PPPO-02-2030934-13

EXPLANATION OF SIGNIFICANT DIFFERENCES TO THE RECORD OF DECISION FOR THE INTERIM REMEDIAL ACTION OF THE NORTHEAST PLUME AT THE PADUCAH GASEOUS DIFFUSION PLANT, PADUCAH, KENTUCKY (DOE/LX/07-1291&D2)

**Explanation of Significant Differences
to the Record of Decision for the Interim Remedial Action
of the Northeast Plume at the
Paducah Gaseous Diffusion Plant
Paducah, Kentucky**

Figure 5. Locations of New and Preexisting EWs Associated with the Northeast Plume IRA at PGDP

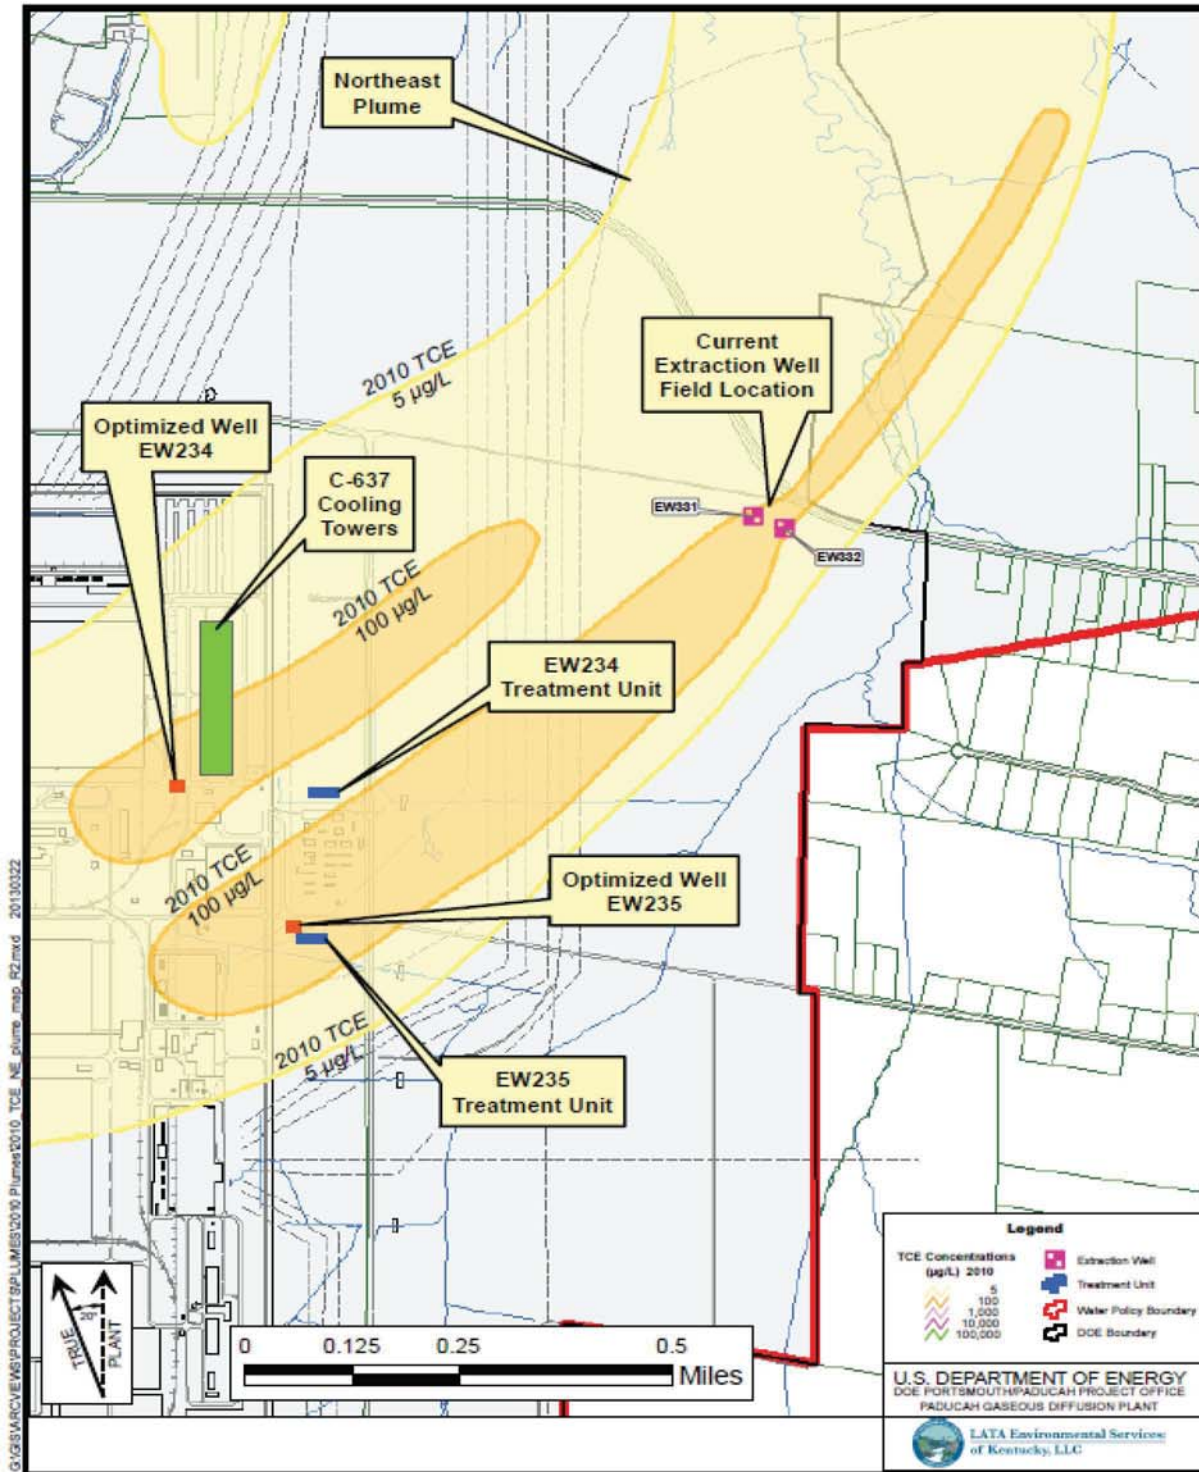
- Northeast Plume EWs (EW234 and EW235) will be located near the eastern edge of the PGDP and the existing EWs (EW331 and EW332) were to be taken out of service.
- Use of the PGDP cooling towers for stripping TCE and 1,1-DCE has been discontinued and will be replaced with engineered water treatment units that utilize air stripping (shallow tray air stripper) for TCE and 1,1-DCE contamination.
- Treated VOC-contaminated groundwater discharge will be through a maximum of two CERCLA designated outfalls. The receiving water body is the Little Bayou Creek, which carries a Kentucky use classification of Recreational.
- A new non-USEC electrical power connection will be installed for the treatment units and EWs (EW234 and EW235).

Well field optimization modeling indicates that a two-well configuration is optimal. The two new wells, EW234 and EW235, are to be located near the eastern edge of the PGDP facility. Refer to Figure 5 for well locations. The EWs (EW234 and EW235) are expected to have an operational flow rate of approximately 150 gpm each. Detailed lithologic logs and grain size analysis to the extent available will be used in well screen and filter pack design of the new EWs (EW234 and EW235).
